TIDAL WAVE AUTO SPA
ROLESVILLE, NC

SW+ PROJECT: 10772
DATE: 12/22/23
DRAWN BY: CPE
CHECKED BY: TLL

UTILITY PLAN AND PROFILES

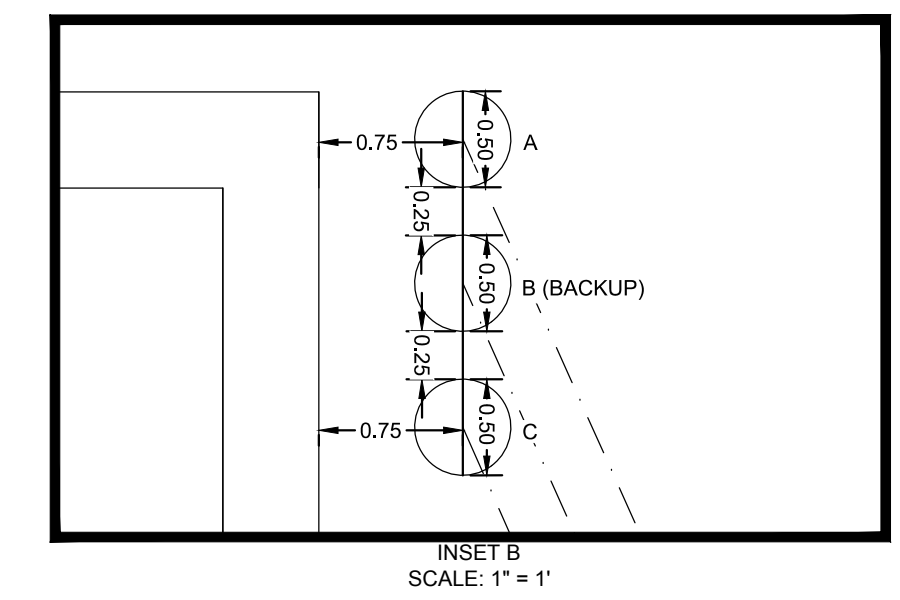
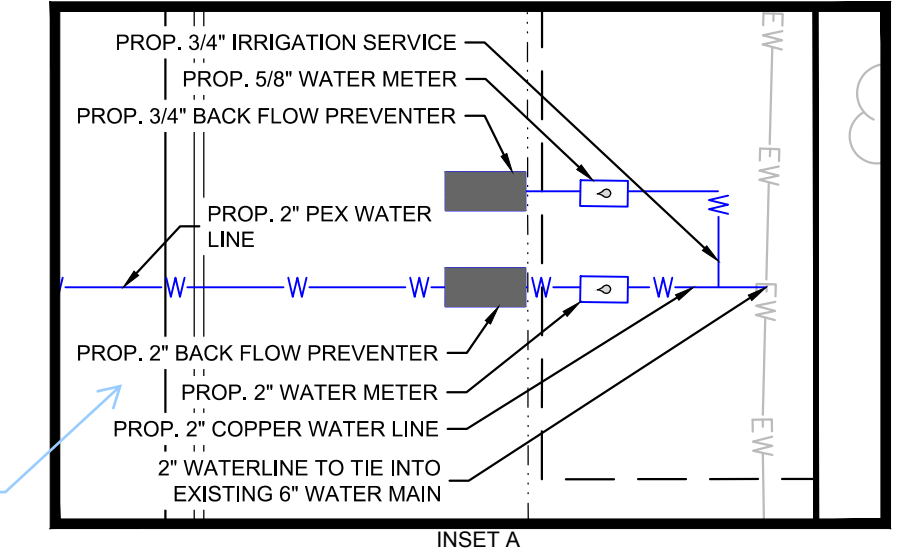
Please coordinate with 7 eleven with the construction of the needed driveway so Raleigh can have access to the water tower.

Because this is a subdivision, both lots must have access to sanitary sewer prior to CD approval.

Please relocate the sanitary sewer service so that it is not running parallel within the utility easement.

Please include a note and sequencing for how the existing water tank access will remain until the drive aisle and driveway are constructed.

Because this is a subdivision, public water must be extended along the frontage of both lots. Water should be extended north to provide the other lot with access to public water.

Please include the Raleigh Standard Utility Notes (CORPUD Handbook Appendix D).

Encroachment agreement will be needed for the curb line located within the easement.

Please provide make and model # for the proposed BFPs with the statement "or Raleigh approved equal".

Signs should be relocated out of the easement.

Please include a note that states the following: Raleigh Water staff may need to be onsite while any construction occurs in the vicinity of the critical water transmission main. Please email WDSserviceRequestDL@Raleighnc.gov at a minimum 72 hours in advance to any work in the vicinity of this critical water transmission main.
